CIRCUIT BREAKER AND IGNITION TIMING - SPRINT

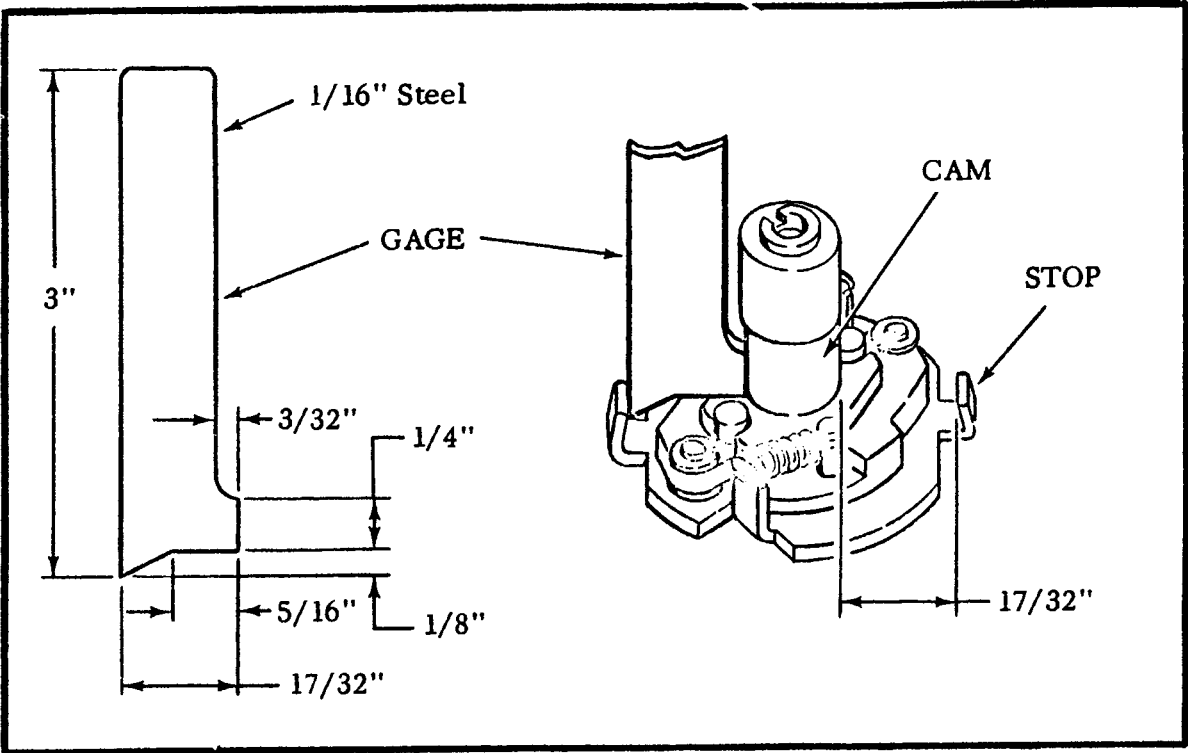
If after setting the advanced timing to 35° B. T. C. at 4500 engine RPM, the retarded timing does not fall within 5° to 10° B. T. C. at 1200 engine RPM (Idle Speed), it will be necessary to remove circuit breaker cover and base plate and bend flyweight stops inward to reduce the amount of spark advance. The stops should be bent an equal amount (approximately 1/8 inch) so that the distance between each stop and the round section at the base of the cam is 17/32 in. (.530). Measurement is shown in diagram on next page.

Note: A convenient gage can be made of a thin piece of flat stock made to dimensions as shown in diagram.

Bending stops inward toward cam retards advanced timing, Therefore the advanced (35° B. T. C.) timing must be readjusted by shifting circuit breaker plate counterclockwise to a new position.

Use strobe timing light and degree plate indicator to recheck timing after circuit breaker plate is reassembled and tightened down.
